# CITY OF CLOVIS

## DRIVEWAY APPROACH ALT. 10' CURB PATTERN

**ST-8A**

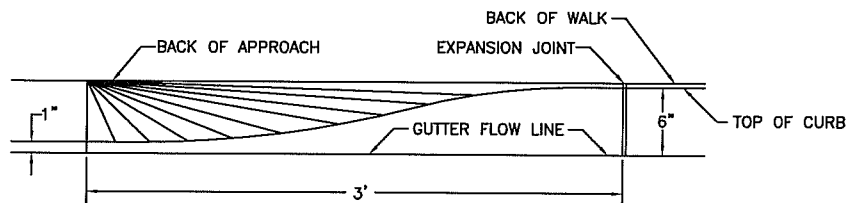
Grammar correction - The approach, sidewalk behind approach, and curb & gutter subgrade shall be compacted to 95%. Other sidewalk subgrade shall be compacted to 95%.

1. APPROACHES AND SIDEWALK SHALL BE CLASS 3 CONCRETE. ~~APPROACHES, SIDEWALK BEHIND APPROACH CURBS & CUTTERS SUBGRADE, COMPACT TO 95%. OTHER SIDEWALK SUBGRADE COMPACT TO 90%.~~
2. BROOM FINISH ON APPROACH AND ON SIDEWALK. ~~MED. SWEAT FINISH ON SIDEWALK IS OPTIONAL OR AS DIRECTED BY THE ENGINEER. DEEP SCORE MARK IN CENTER OF APPROACH WHEN THROAT IS WIDER THAN 20'.~~
3. BROOM FINISH SHALL BE PERPENDICULAR TO THE PATH OF TRAVEL ON SIDEWALKS, AND PARALLEL TO THE PATH OF TRAVEL ON CURB & GUTTER. Medium
4. NOT MORE THAN 60% OF CURB FACE MAY BE USED FOR DRIVEWAY APPROACH OPENING.
5. EXPANSION JOINT MATERIAL SHALL CONSIST OF 1/4" PREMOLDED JOINT FILLER MEETING ASTM DESIGNATION D 1751.
6. ALL WORK CONSTRUCTED BY THIS STANDARD SHALL BE COMPLETED IN COMPLIANCE WITH CURRENT ADA REGULATIONS.
